### ADDENDUM NUMBER TWO

#### RFB 10-1468 Graham Oaks Nature Park Improvements

The above listed solicitation is hereby amended and clarified through the issuance of this addendum.

DATE: 05/26/21  
 DRAWN BY: JLD  
 CHECKED BY: JLD  
 JOB NO.: 072180  
 ASSESSOR: [blank]  
 SHEET NO.: **C6.03**  
 SHEET TOTAL: **54** OF **67**  
 337272-20

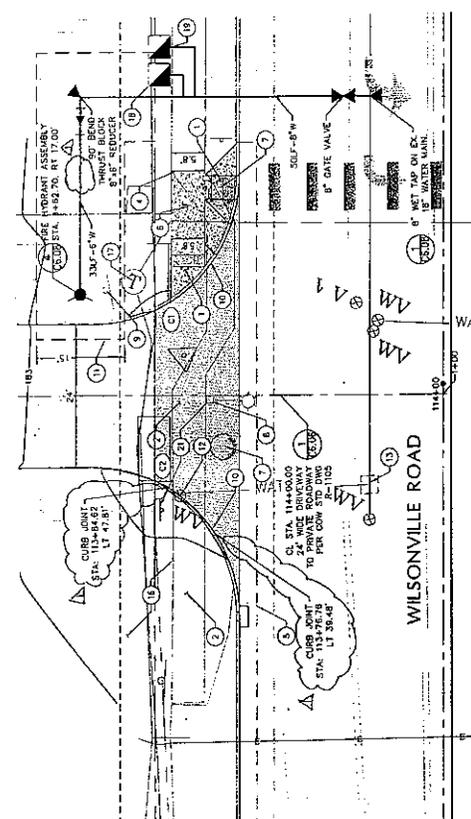
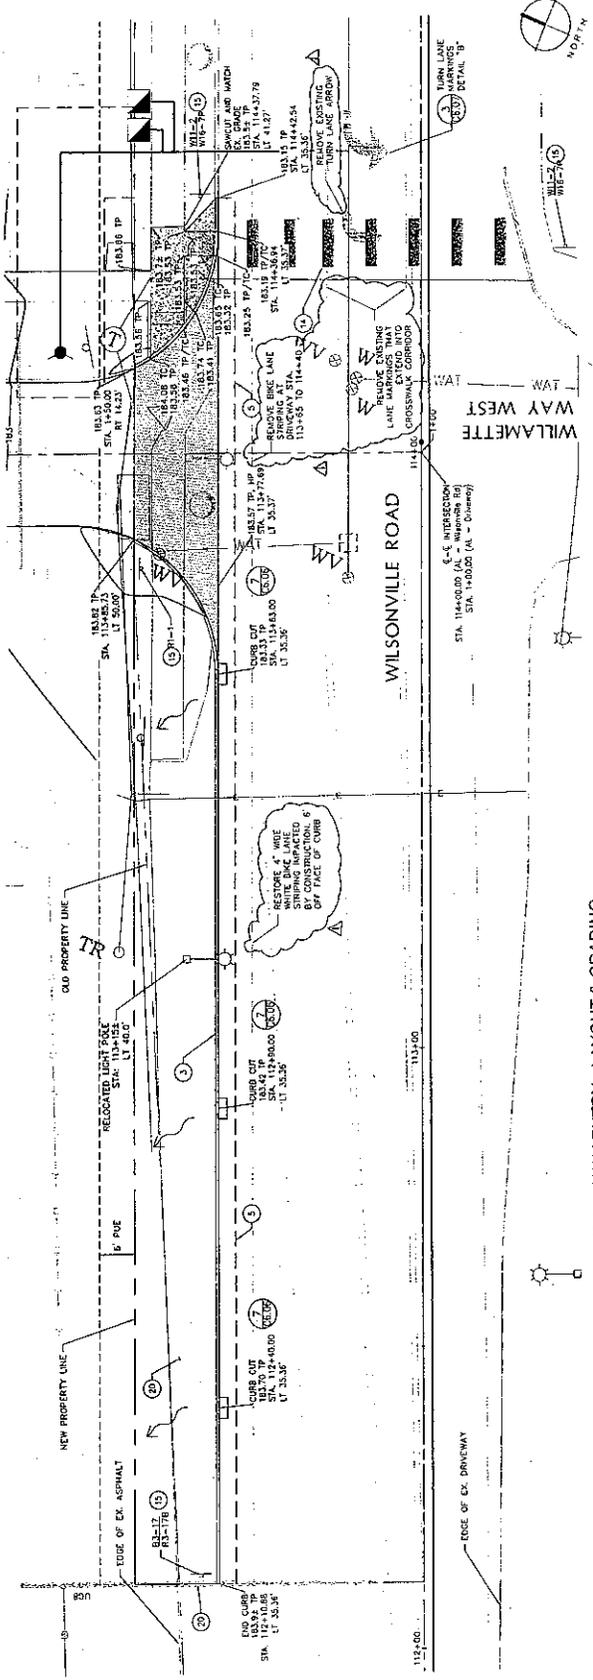
**Revised Drawing** – Drawing C6.03: Revise per the attached drawing and revision call outs to address City of Wilsonville Public Works permit review.

4.4.1 ELEVATION AT TYPICAL ENTRANCE SIGN  
Scale: 1 1/2" = 1'

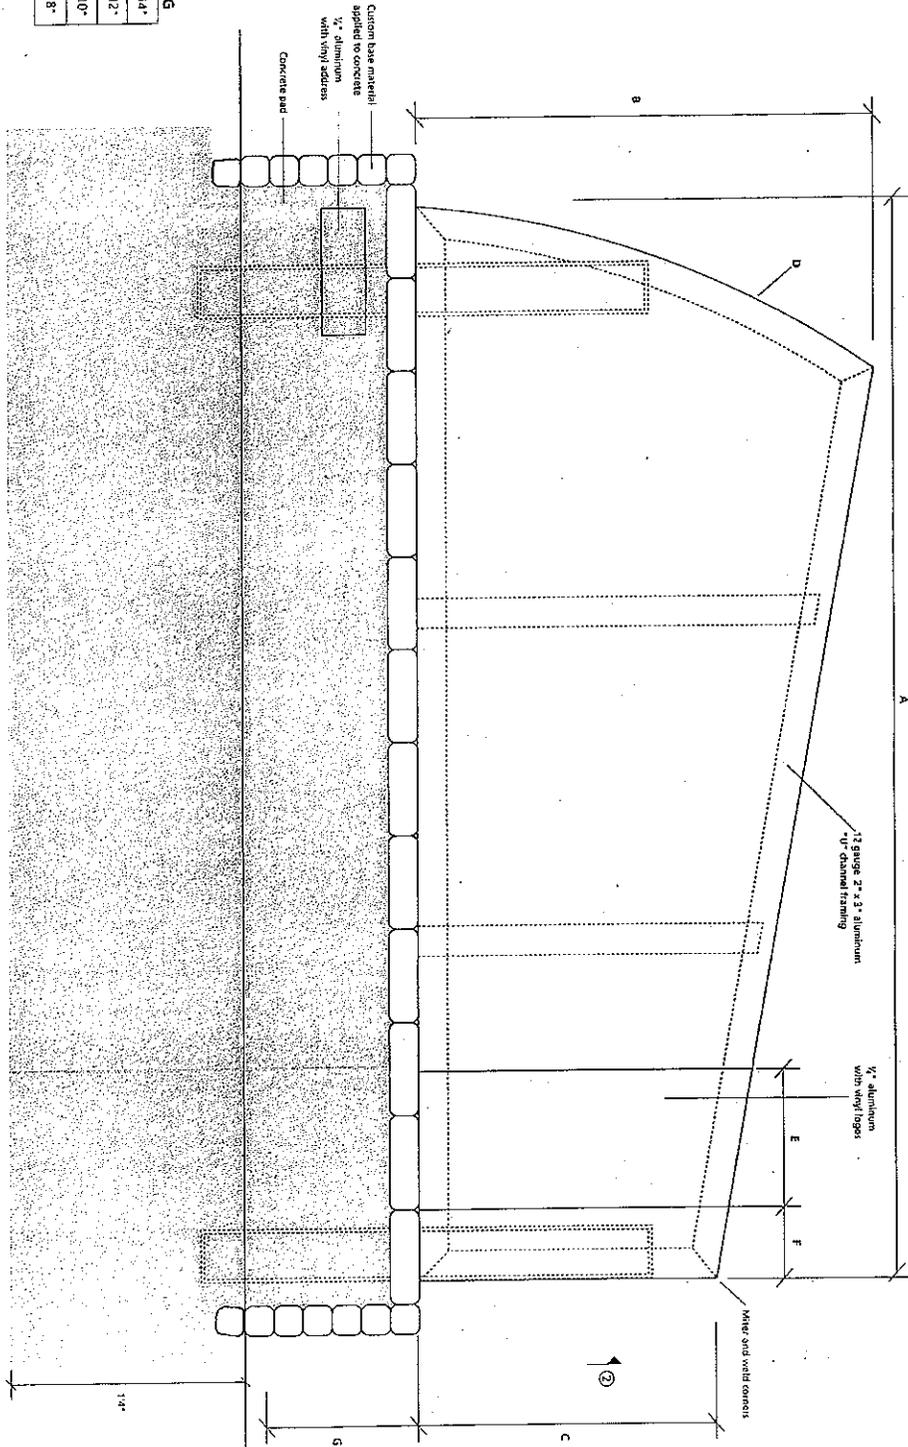
**Revised Drawing** – Drawing S5.01: Revise detail 3/S5.01 to include stone veneer per detail 5/L5.01, specification Section 044300 – Stone Masonry and the Metro Standard Signage manual drawings 4.4. The footing for the entrance sign shall be 9'-0" long.

5.7.1 ELEVATION AT TYPICAL REGULATORY SIGNAGE  
Scale: 2" = 1'

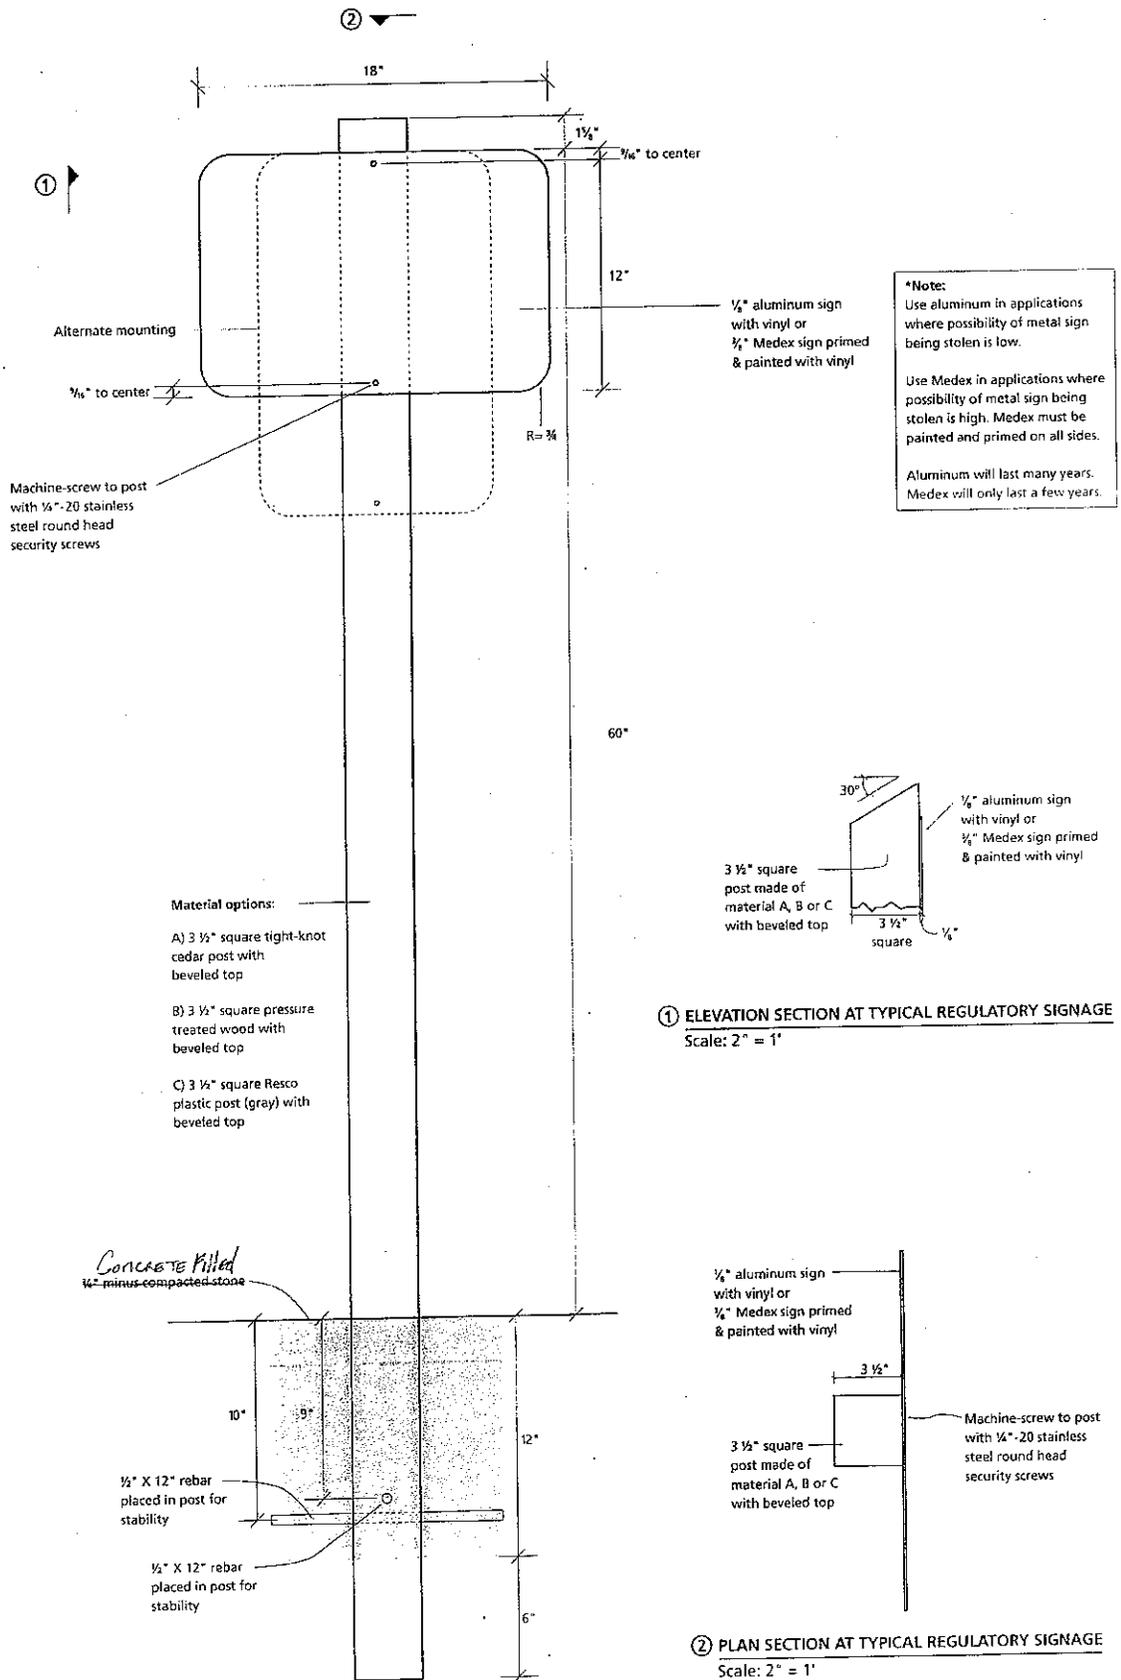
12. Signage posts and panels including: Interpretive, regulatory, trail markers, and wayfinding. The signage panels for the entry sign will be Owner provided while the base is installed by Contractor per details. Contractor to furnish and install two regulatory weight limit signs as called out on L1.1 and ADA signs as indicated on drawings. Details for the installation of the entrance sign, trailhead signage, trail post signage and regulatory signage is included in information made available per Addendum #2. See attached.

POST & CABLE FENCE DETAIL

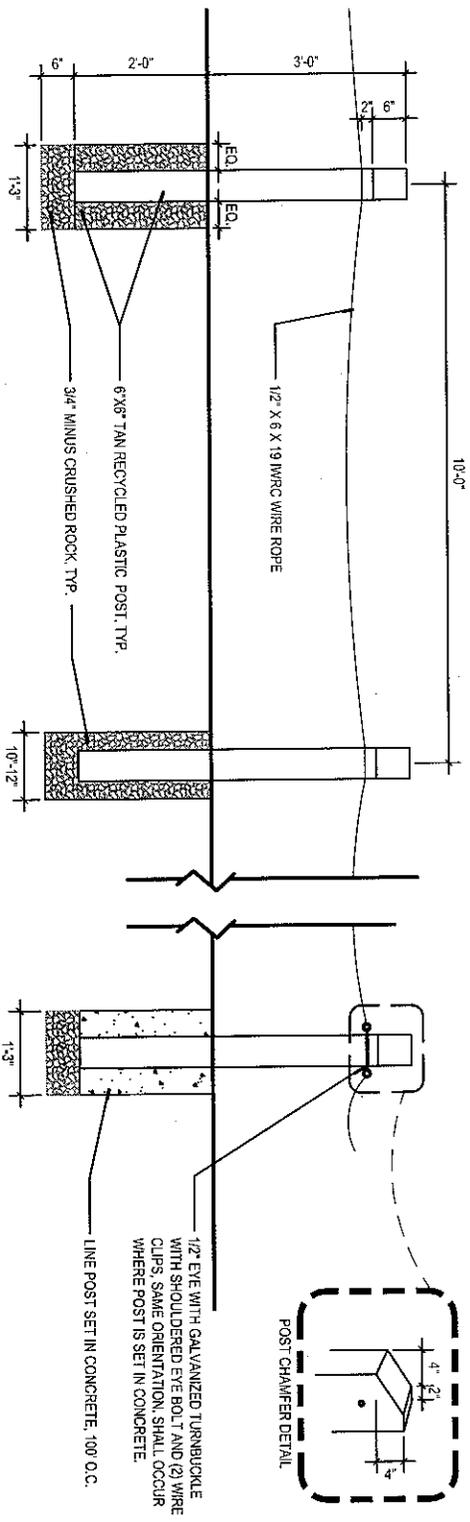
**Revised Drawing** – Drawing 9/L5.04: Revise per the attached detail/drawing.
